CALL NO. 112
CONTRACT ID NO. 141246
ADDENDUM # 1

Subject: Warren County, NHPP 0651 (097)
Letting July 11, 2014

- (1) Revised - Plans - R2 & R2A
- (2) Revised - Bid Items - Pages 108-109 of 109

An Equal Opportunity Employer M/F/D

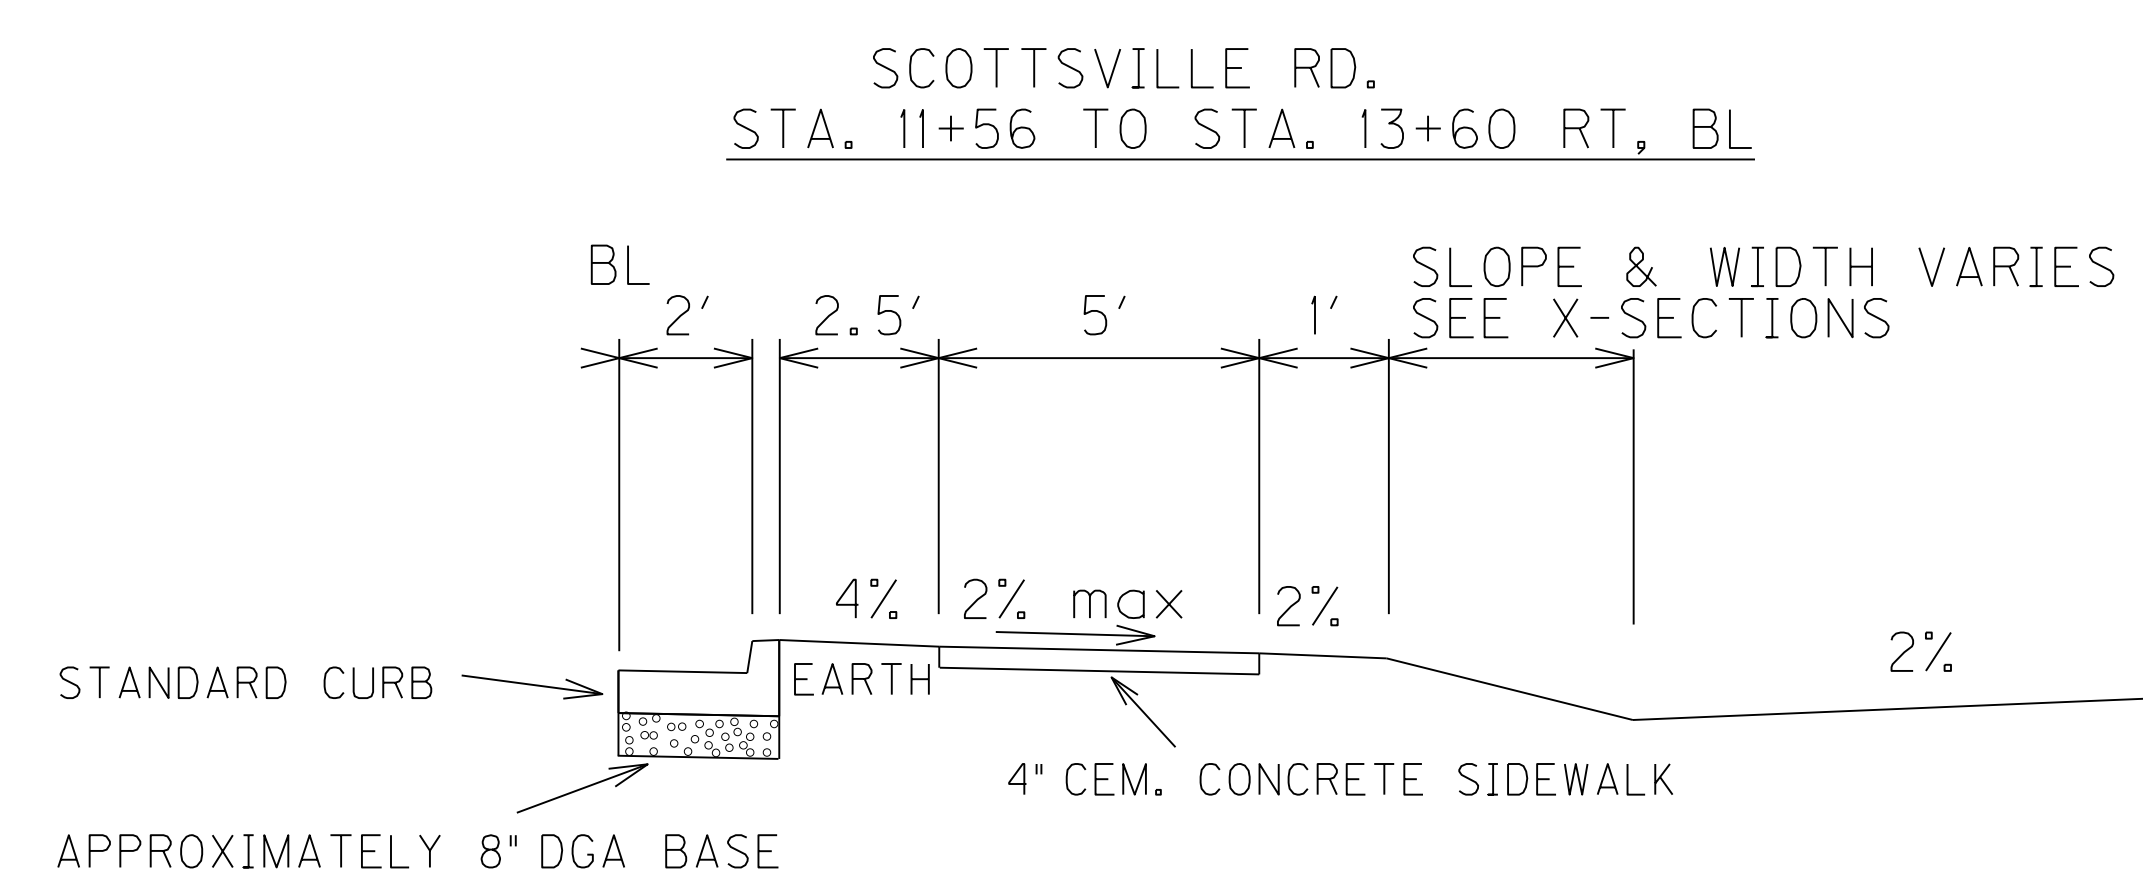
REVISED: 6/24/2014
